### ADDENDUM NO. 3 to the

## Sally Ann Creek AOP Crossing #1 Culvert Replacement

### Nez Perce Tribe – Dated: 3/6/2025

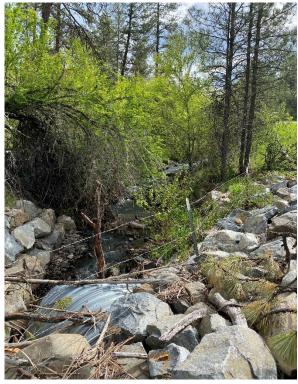
8. Where is the course granular backfill for the geocell located? It says in the drawings that it is a govt supplied source, but it is not clear where it has to come from. Haul distance? Do we need something to load it with?

The course granular backfill material for the geocell is not government sourced, that must have been an error in the design plans. Government sourced/ provided materials can be found in the RFP in Section 3.2 Supplied Materials.
